Access Compliance Report

Public Rights-of-Way

(Curb Ramps)

Intersection ID: 11488	Main Street: N_CHURCH_ST	Cross Street: W_12TH_ST	Location: NW
ADA ID: 4182BD117515	Ramp Type: BlendTrans1	Initial Pass/Fail: Fail	Overall Compliance: No
Severity Score: 8.75			
Codes/Mitigation Info/Possible Solution		Field Measurements/Component Compliance

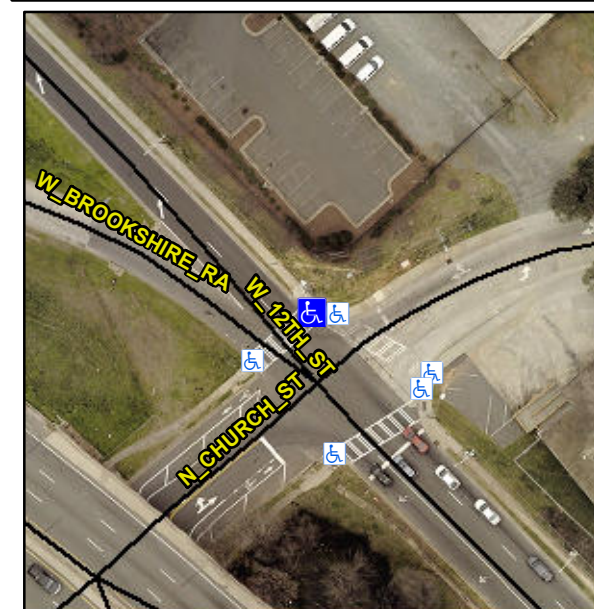
Not Found, R304.5.1

Compliance	Description	Data	Compliance	Description	Data
N/A	Ramp Length (in)	81.5	Yes	BlendTrans Slope (%)	3.0
No	Ramp Width (in)	45.0	Yes	BlendTrans XSlope (%)	0.5
N/A	Flare Type LT	N/A	N/A	Flare Type RT	N/A
N/A	Flare Slope LT (%)	N/A	N/A	Flare Slope RT (%)	N/A
N/A	Flare Traversable LT?	N/A	N/A	Flare Traversable RT?	N/A
N/A	Landing Length (in)	N/A	N/A	DWS Provided?	N/A
N/A	Landing Width (in)	N/A	N/A	DWS Contrast?	N/A
N/A	Landing Slope (%)	N/A	N/A	DWS Length (in)	N/A
N/A	Landing X Slope (%)	N/A	N/A	DWS Full Width?	N/A
N/A	Landing Curb? (Y/N)	N/A	N/A	DWS Offset (in)	N/A
N/A	Shared Landing?	N/A			
N/A	Gutter Ponding?	N/A	N/A	Gutter Slope (%)	N/A
N/A	Gutter Lip Ht (in)	N/A	N/A	Gutter X Slope (%)	N/A
N/A	Painted X Walk1?	Yes	N/A	Painted X Walk2?	N/A
	X Walk 1 Direction	To SW		X Walk 2 Direction	N/A
	X Walk 1 Width (in)	125.0		X Walk 2 Width (in)	N/A
	X Walk 1 Slope (%)	3.9		X Walk 2 Slope (%)	N/A
	X Walk 1 X Slope (%)	3.4		X Walk 2 X Slope (%)	N/A

N/A	Ramp inside XWalk1?	Yes	N/A	Ramp inside XWalk2?	N/A
	Road Slope (%)	3.4		Clear Space?	N/A
	Road X Slope (%)	3.9	N/A	Clear Space to XWalk (in)	N/A
N/A	Any Obstructions?	N/A	N/A	Storm Grate/Utility Hazard?	N/A
	Obstruction Type			Storm Grate/Utility Type	
		N/A			N/A
			Yes	Surface Condition? (G/P)	Good
			No	Curb Slope (%)	29.0

Remove & Replace Curb Ramp With Two New Directional Ramps or Equivalent.
